Access Compliance Report

Public Rights-of-Way

(Curb Ramps)

Intersection ID: 29153	Main Street: BRIAR_ROSE_CT	Cross Street: HIGHLAND_PARK_DR	Location: W
ADA ID: C1D4EA3D31D2	Ramp Type: PerpDiag	Initial Pass/Fail: Fail	Overall Compliance: No
Severity Score: 8.75			
Codes/Mitigation Info/Possible Solution		Field Measurements/Component Compliance

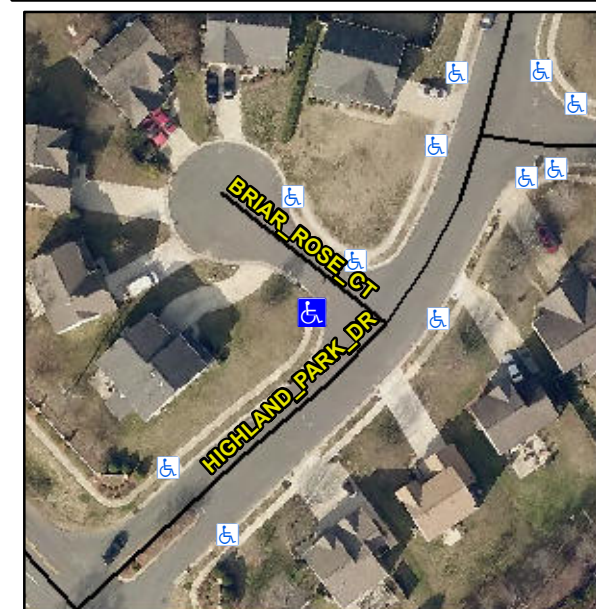
R304.5.1

Compliance	Description	Data	Compliance	Description	Data
N/A	Ramp Length (in)	50.0	Yes	Ramp Slope (%)	6.8
No	Ramp Width (in)	47.0	Yes	Ramp XSlope (%)	0.5
N/A	Flare Type LT	N/A	N/A	Flare Type RT	N/A
N/A	Flare Slope LT (%)	N/A	N/A	Flare Slope RT (%)	N/A
N/A	Flare Traversable LT?	N/A	N/A	Flare Traversable RT?	N/A
N/A	Landing Length (in)	N/A	N/A	DWS Provided?	N/A
N/A	Landing Width (in)	N/A	N/A	DWS Contrast?	N/A
N/A	Landing Slope (%)	N/A	N/A	DWS Length (in)	N/A
N/A	Landing X Slope (%)	N/A	N/A	DWS Full Width?	N/A
N/A	Landing Curb? (Y/N)	N/A	N/A	DWS Offset (in)	N/A
N/A	Shared Landing?	N/A			
N/A	Gutter Ponding?	N/A	N/A	Gutter Slope (%)	N/A
N/A	Gutter Lip Ht (in)	N/A	N/A	Gutter X Slope (%)	N/A
N/A	Painted X Walk1?	No	N/A	Painted X Walk2?	No
	X Walk 1 Direction	To SE		X Walk 2 Direction	To NE
N/A	X Walk 1 Width (in)	N/A	N/A	X Walk 2 Width (in)	N/A
	X Walk 1 Slope (%)	1.5		X Walk 2 Slope (%)	1.8
	X Walk 1 X Slope (%)	0.2		X Walk 2 X Slope (%)	2.1

N/A	Ramp inside XWalk1?	N/A	N/A	Ramp inside XWalk2?	N/A
	Road Slope (%)	1.6	N/A	Clear Space?	N/A
	Road X Slope (%)	1.3	N/A	Clear Space to XWalk (in)	N/A
N/A	Any Obstructions?	N/A	N/A	Storm Grate/Utility Hazard?	N/A
	Obstruction Type			Storm Grate/Utility Type	
		N/A			N/A
			Yes	Surface Condition? (G/P)	Good

Remove & Replace Curb Ramp With Two New Directional Ramps or Equivalent.
